Environmental Protection Agency Region 6
Recommended Determination
on a Request by the U.S. Army Corps of Engineers
to Modify the Bayou aux Carpes Clean Water Act
Section 404(c) Designation

April 2009

Part II: Response to Comments

Responsiveness Summary

FIGURE 1: IER 12

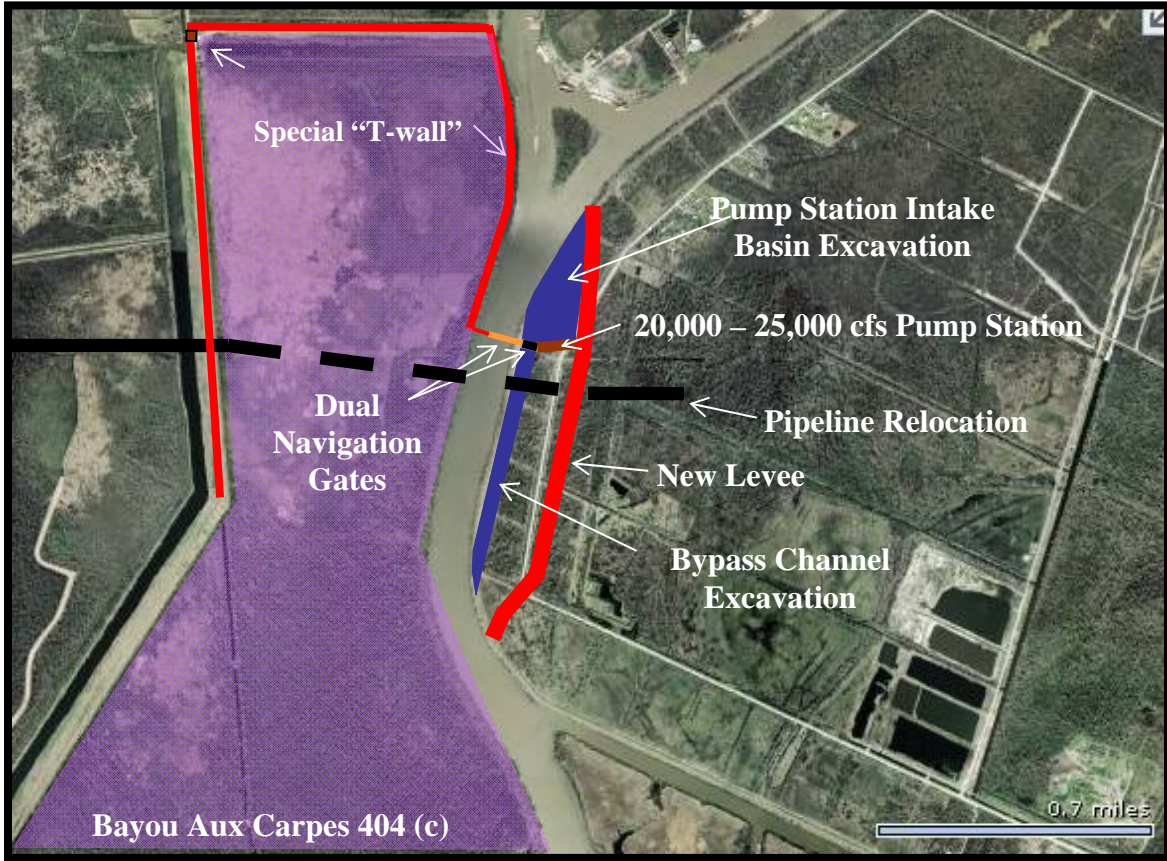
We did not find one map that identified the location of the existing Enterprise pipeline nor a discussion of the impacts of relocation of the pipeline on the BAC wetlands. In Appendix K figure 1 is a dashed line labeled pipeline relocation. Does this pipeline belong to Shell? It is identified on earlier corps maps as a Shell pipeline (USACE, 1971). There should be a full discussion describing how the relocation will prevent any direct or indirect impacts to the BAC. Will the old pipeline be removed? How old is it? How much will be relocated? Between what reference points will the work be done? (point A to point B). Will the pipeline segment reconnect to the old pipeline. We request the amended IER include an expansion of the discussion section fully explaining the pipeline relocation procedure and impacts to the BAC.

Diagram 2

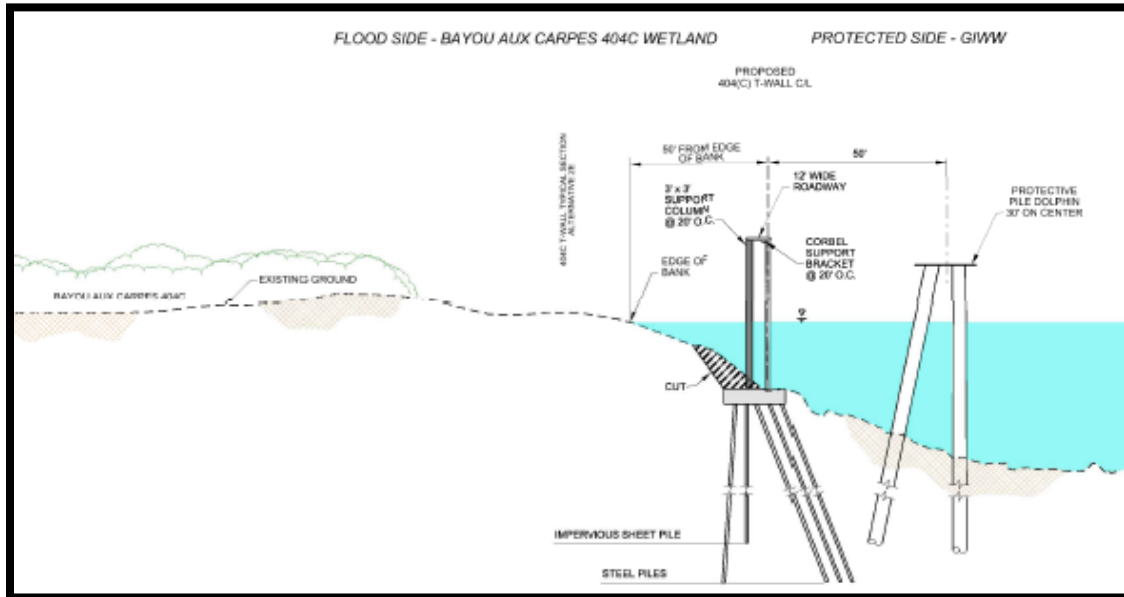
"In the GIWW adjacent to the Bayou aux Carpes CWA Section 404(c) area, 2,000 linear feet (LF) of foreshore dike protection using 650 lb stone would be constructed to prevent impacts (i.e., scouring, bank erosion, etc.) from occurring within the 404c area due to the discharge from the 20,000 cfs pump station (figure 4a, 4c, and 4d; diagram 2). This foreshore dike protection would be constructed within the GIWW adjacent to but not within the Bayou aux Carpes CWA Section 404(c) area. Foreshore protection would not be expected to alter existing hydrologic conditions within the Bayou aux Carpes CWA Section 404(c) area." IER at 28; see also IER at 29, diagram 2.
